# Conceptual Review Agenda

Schedule for 05/18/15 to 05/18/15

# 6617 S College Marijuana Cultivation Facility

**Re:** 6617 S College - Medical Marijuana and Cultivation Facility - Expansion

**MAIN FLOOR ADDITION PLAN**

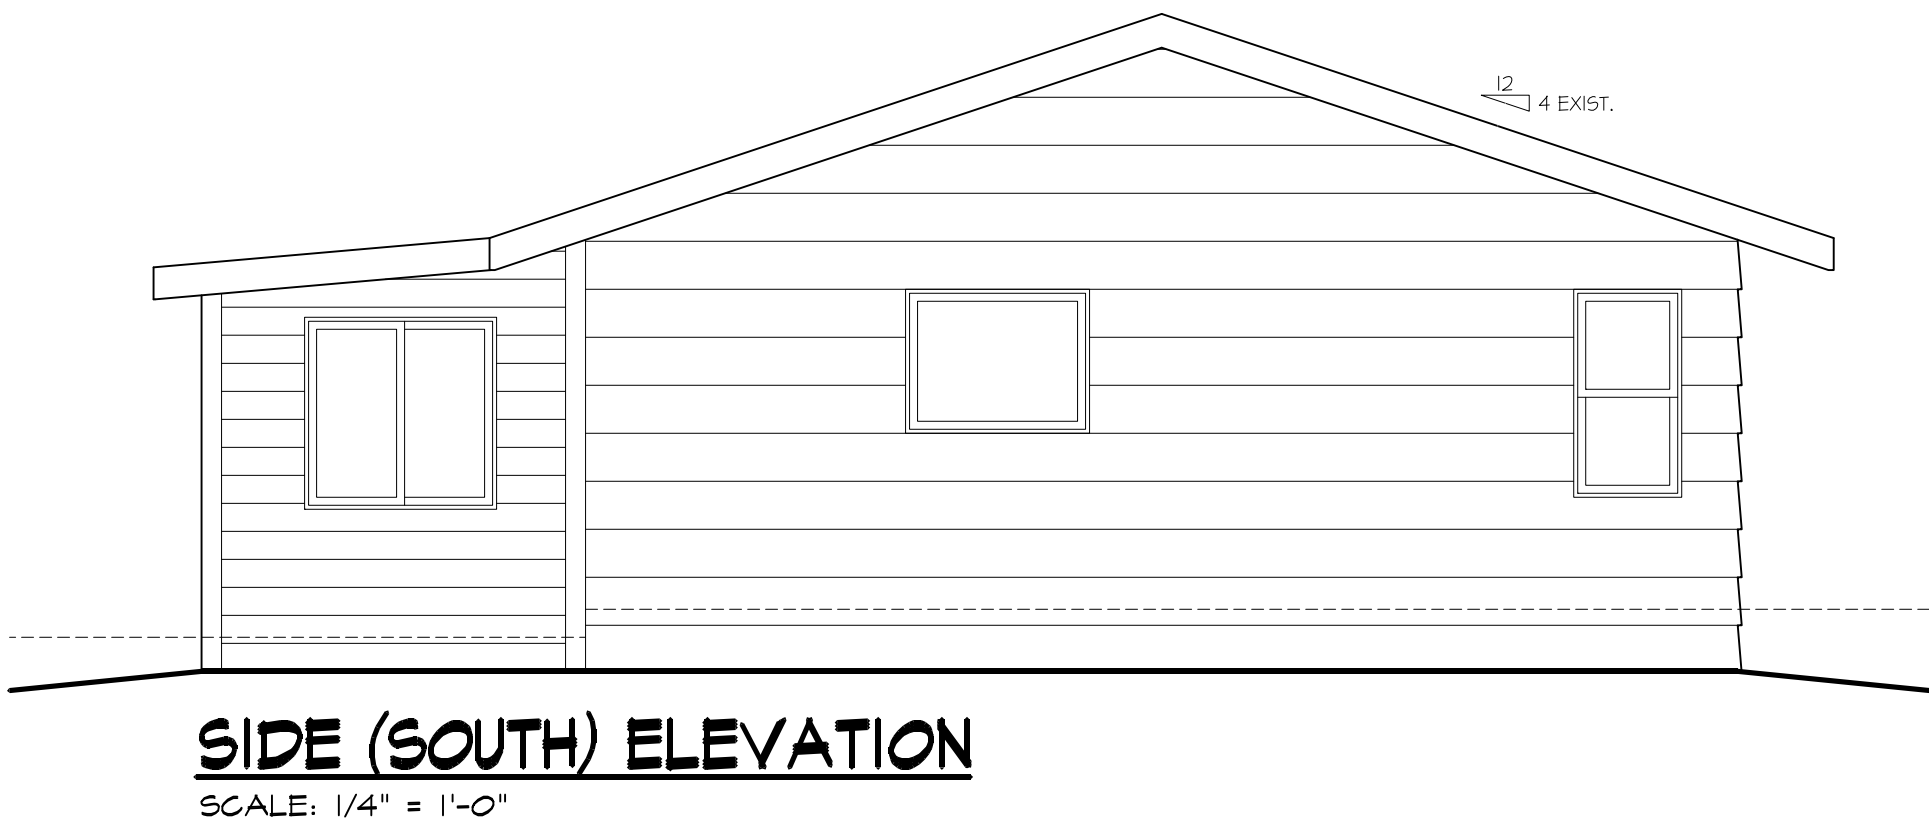
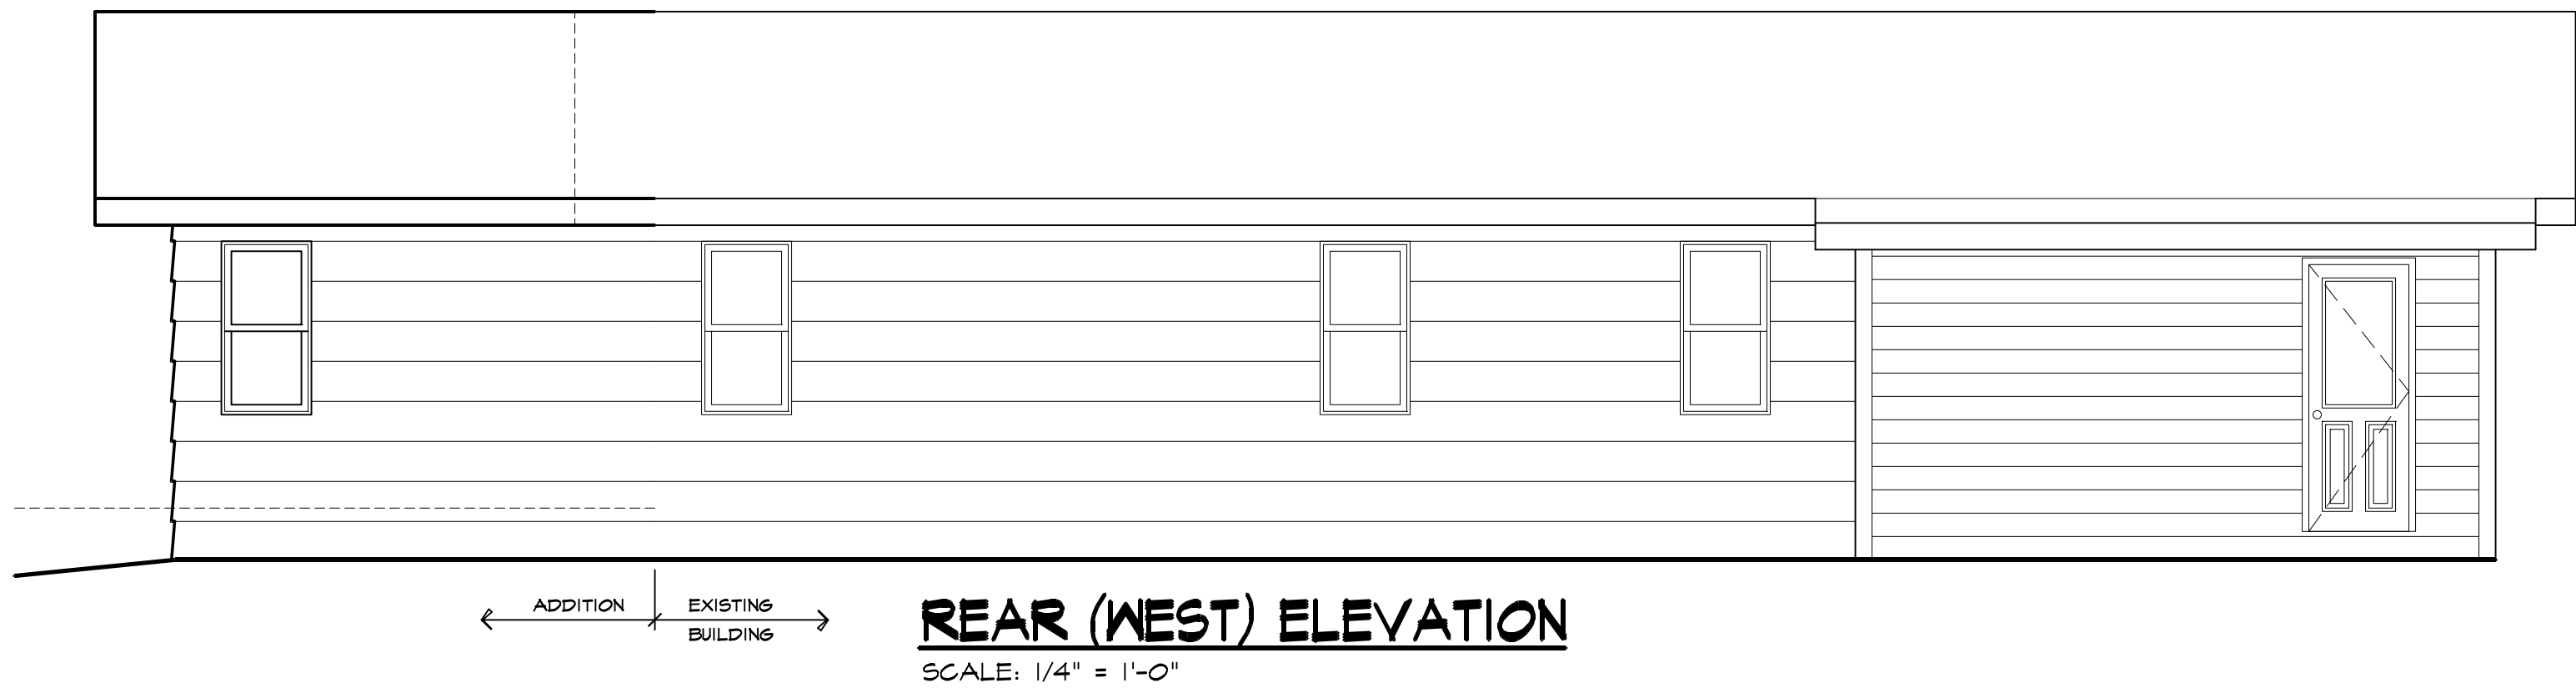
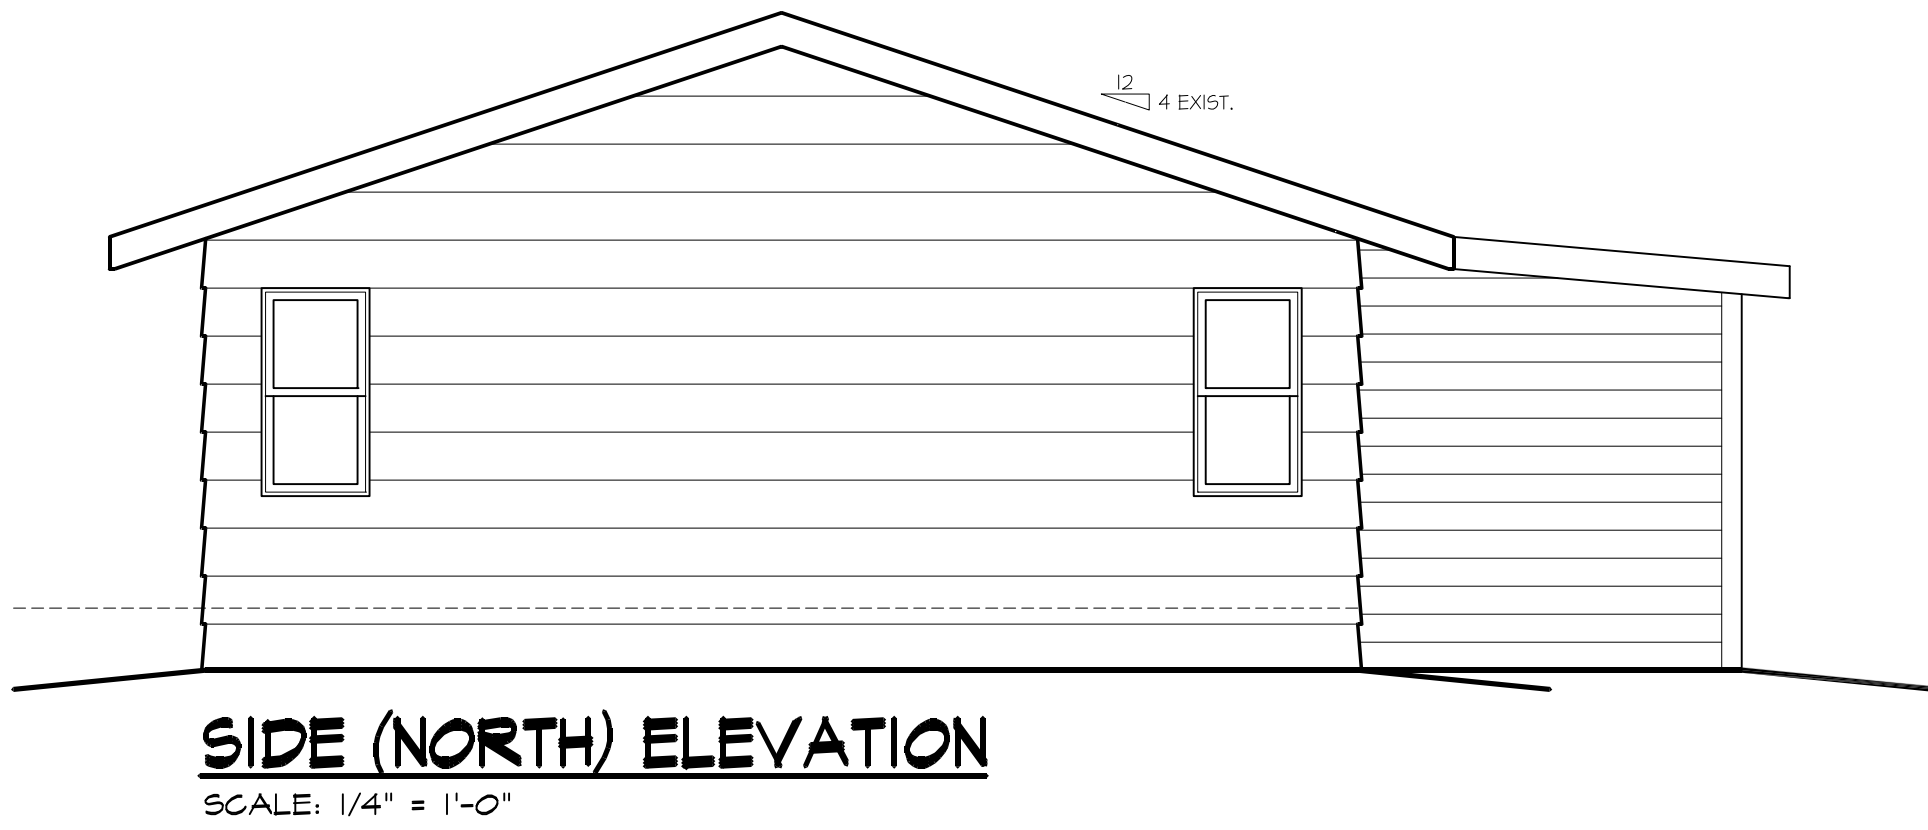
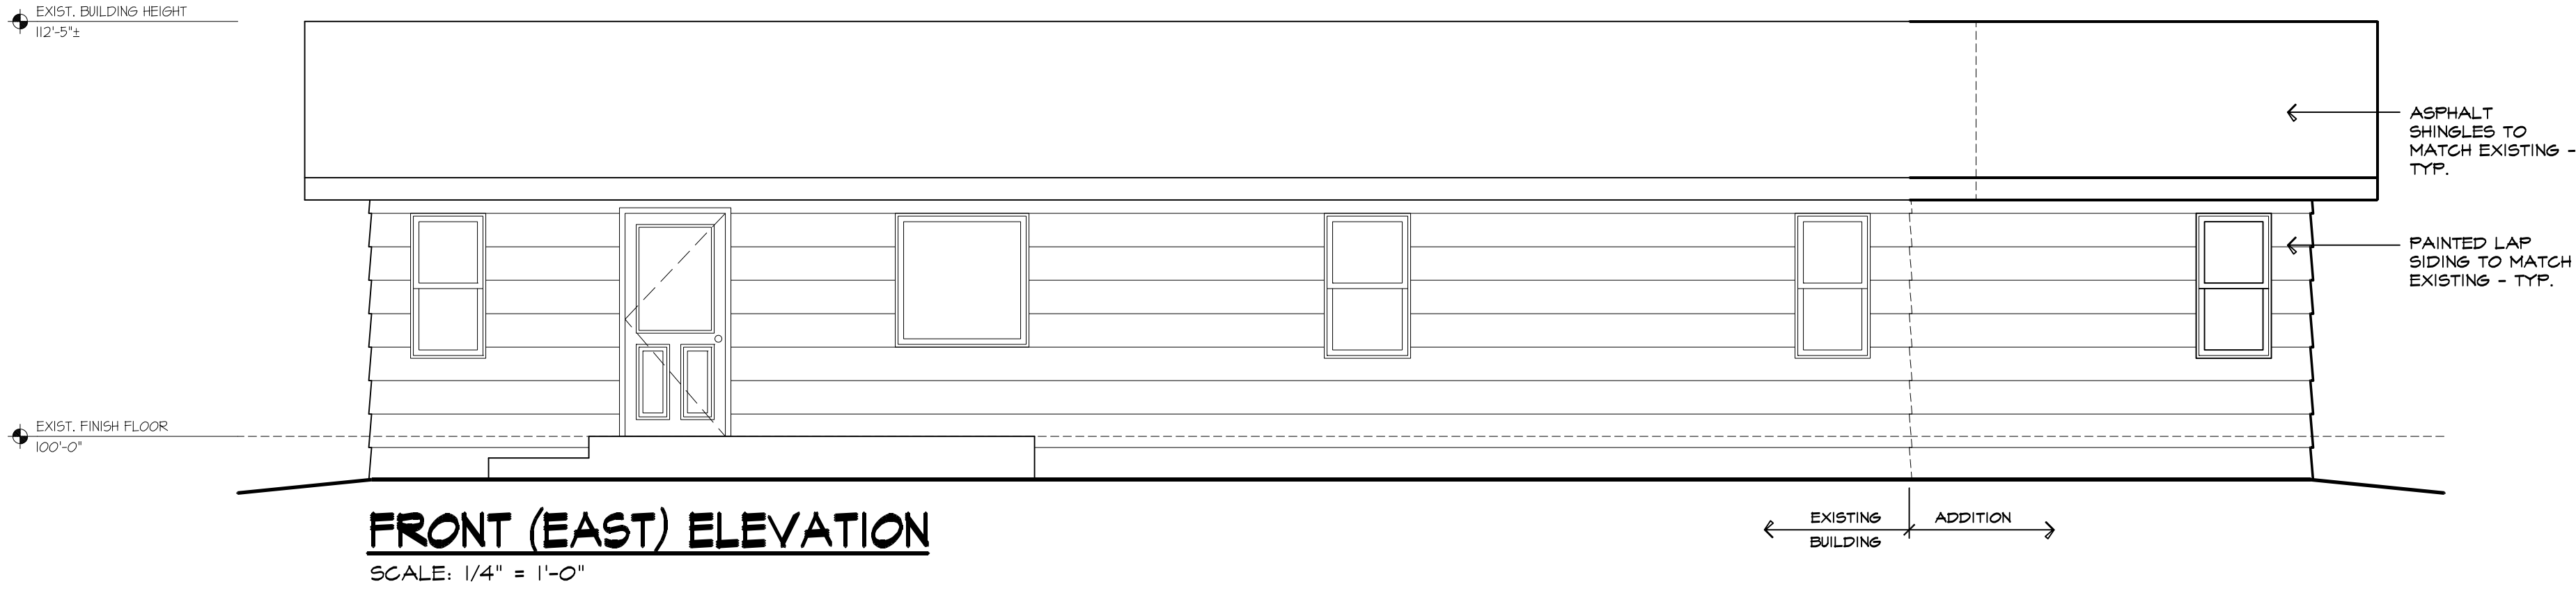
1. A 15 foot landscaping strip is required across adjacent to the drive way entrance off College being tied into a 5' landscaping strip adjacent to both sides of the driveway. I'll defer to the project planner as to how far this landscaping requirement goes. Does it end just west of the proposed building or is it required to go further including the insulation business operation?

4. The parking lot for the retail customer area must be re-paved. The perimeter of the parking lot must be screened or landscaped in accordance with Section 3.2.1(E)(4). The interior must be landscaped in accordance with Section 3.2.1(E)(5).

SHEET TITLE:  
**GROW HOUSE ADDITION PLAN**

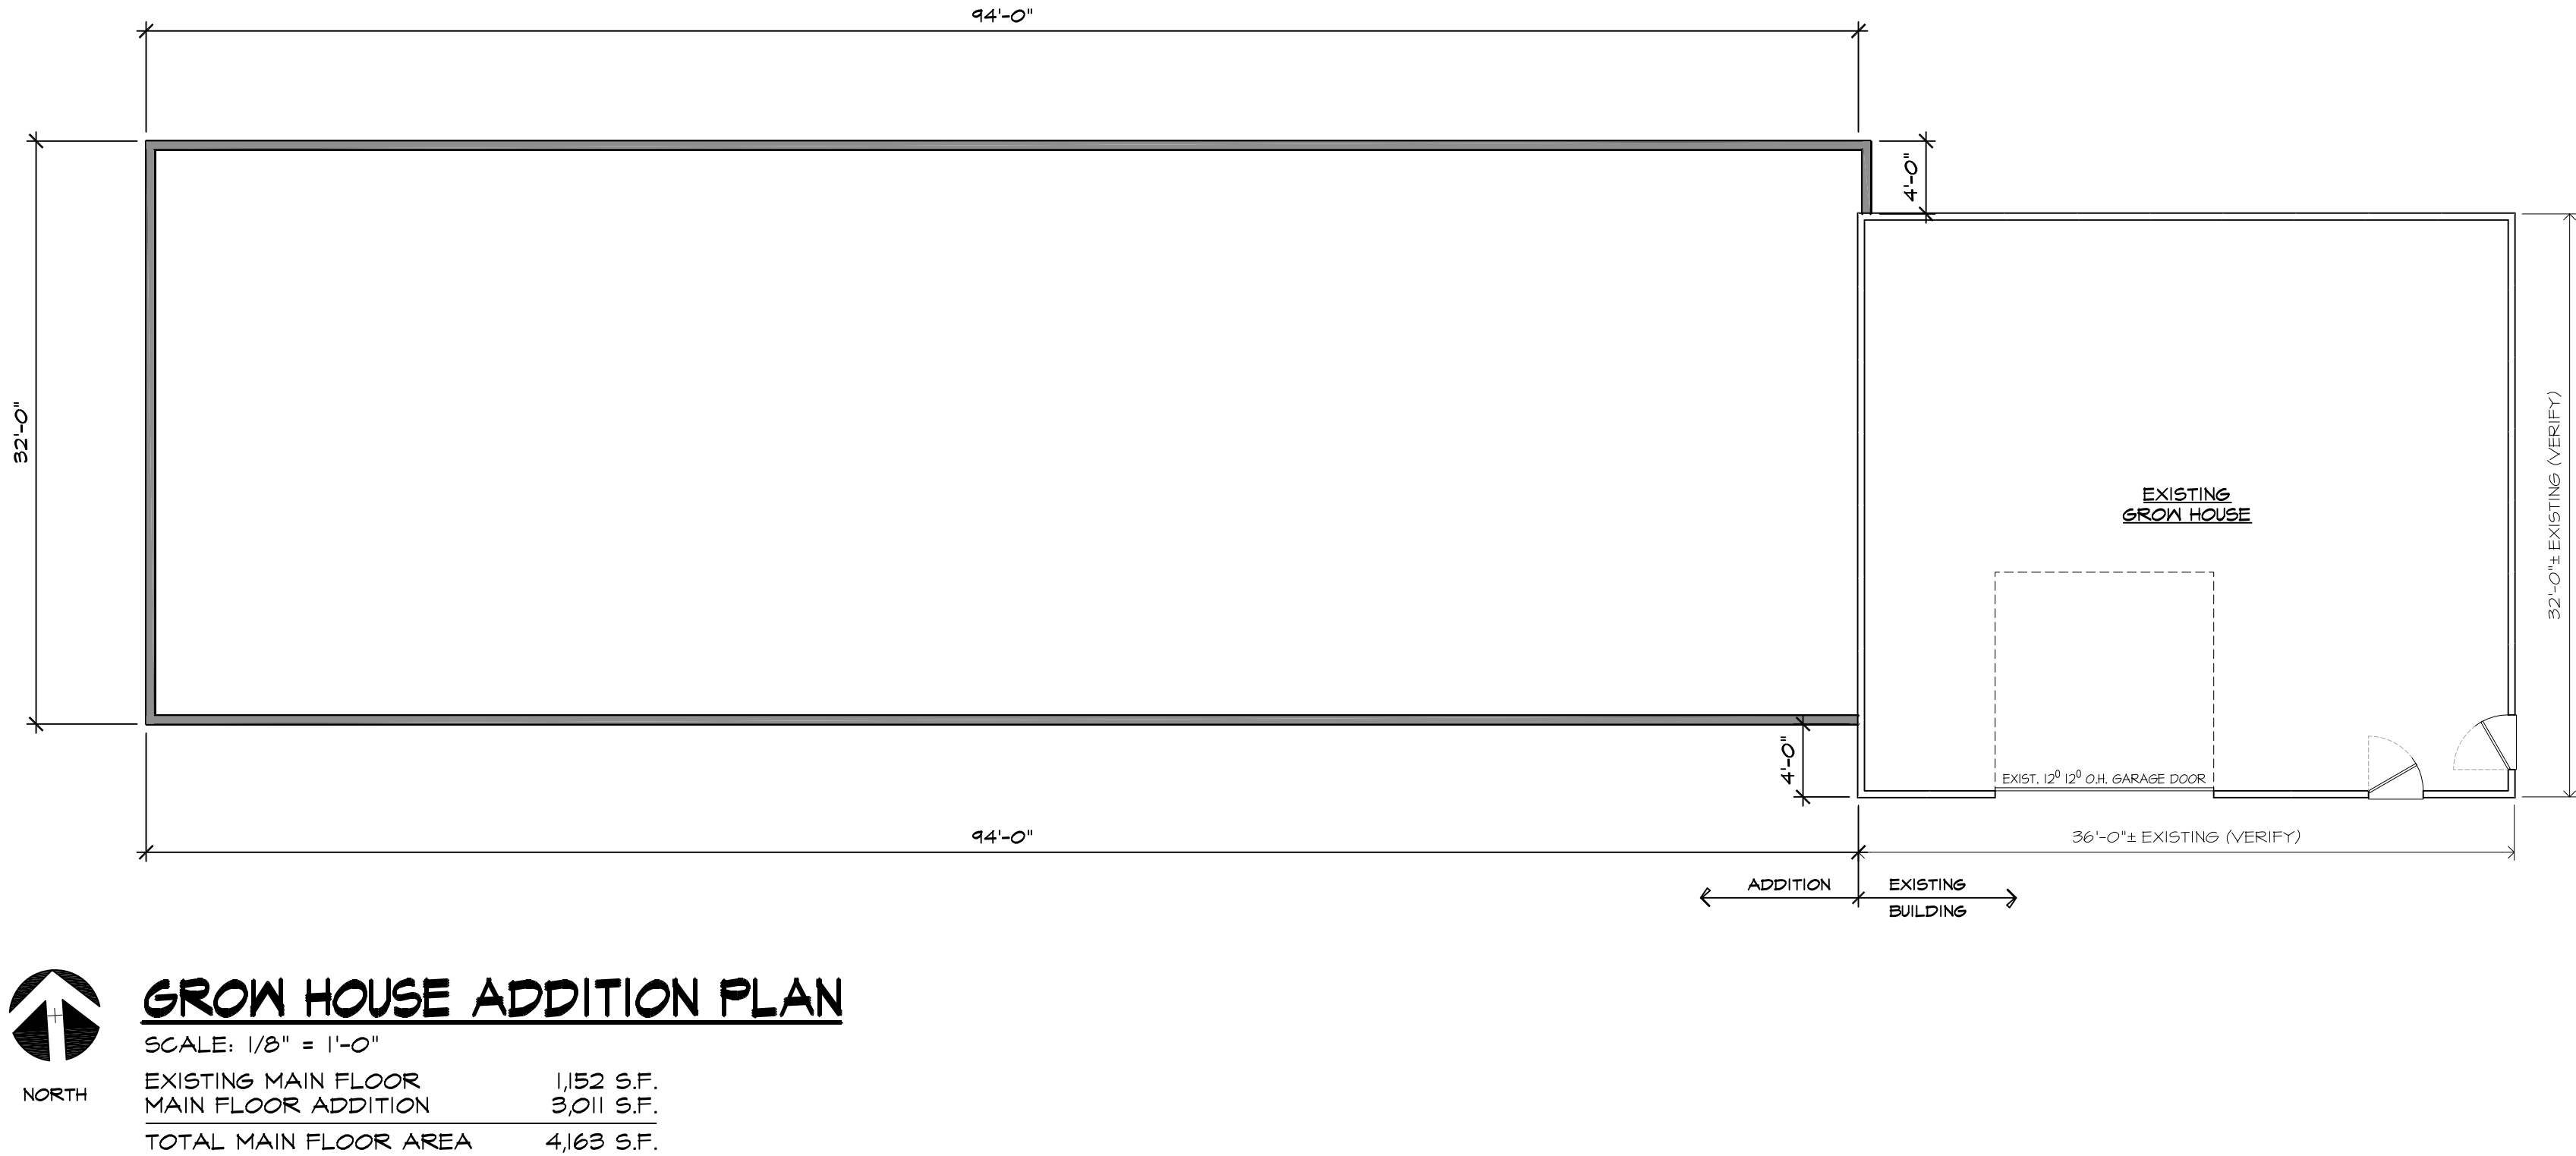
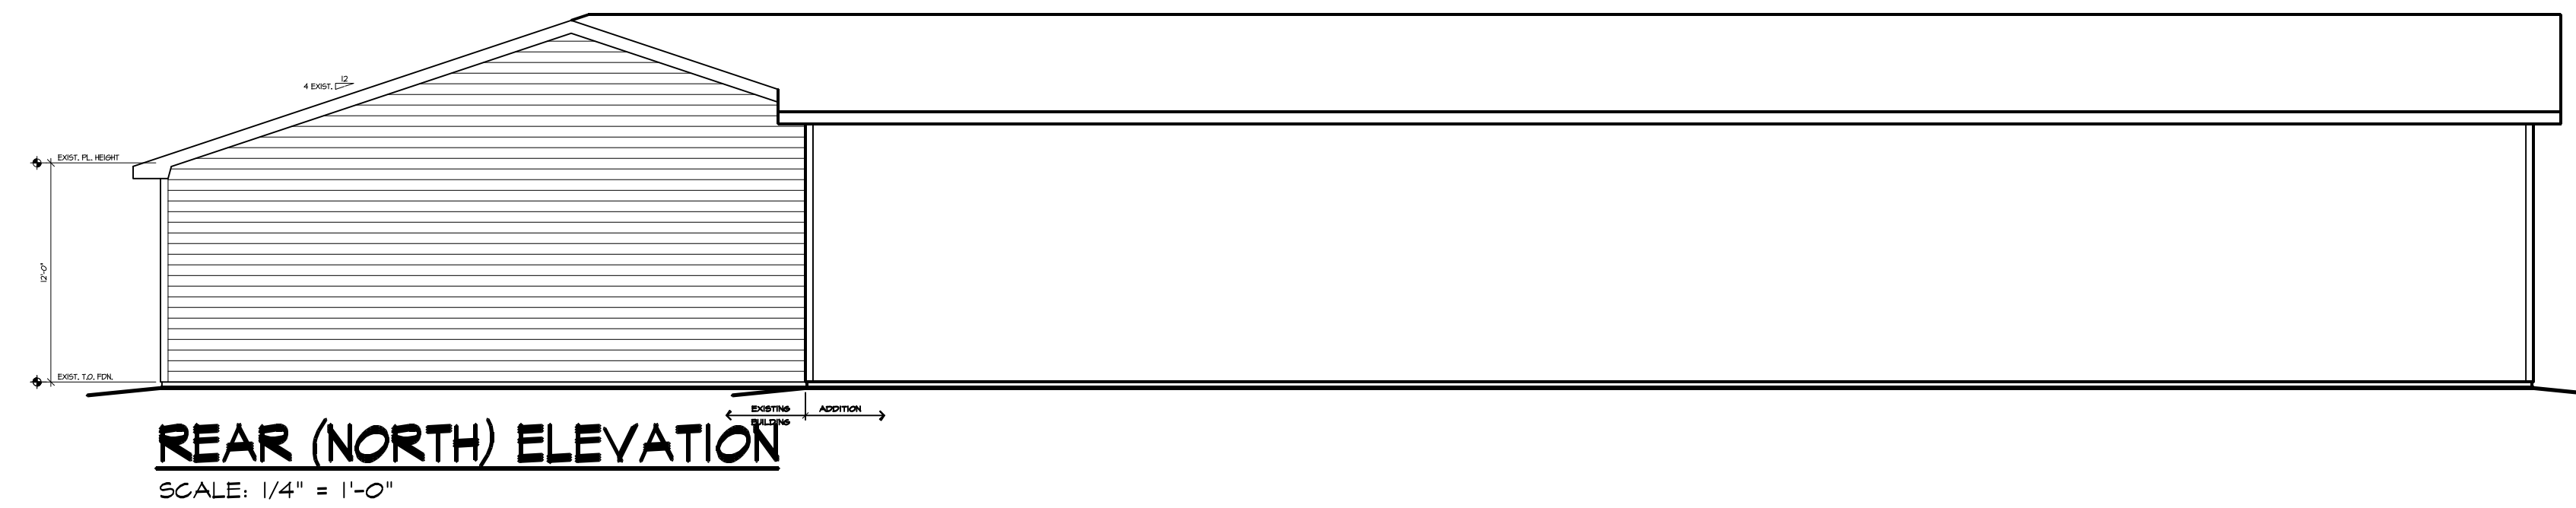
A fire access lane is required to within 150' of all portions of building perimeters. The cultivation facility will be out of access unless a fire lane is provided and dedicated as an Emergency Access Easement. A turnaround would also appear to be needed. Code language and fire lane specifications provided below:

Buildings exceeding 5000 square feet shall be sprinklered or fire contained. If containment is used, the containment construction shall be reviewed and approved by the Poudre Fire Authority prior to installation. Should the proposed 3,000 sq. ft. addition to the existing building create a total fire area of 5,000 sq. ft., a fire sprinkler system or fire containment will be required.

Grow facilities for marijuana must meet minimum fire hazard and exit requirements. The applicant is responsible for obtaining and completing a "Marijuana Check Sheet". The check sheet is available from the the City of Fort Collins at such time a business permit is obtained. The completed check sheet is to be returned to the Poudre Fire Authority as directed. This document will be reviewed with the applicant at time of final inspection. For more information, contact PFA Captain Shawn McGaffin at 416-2863.
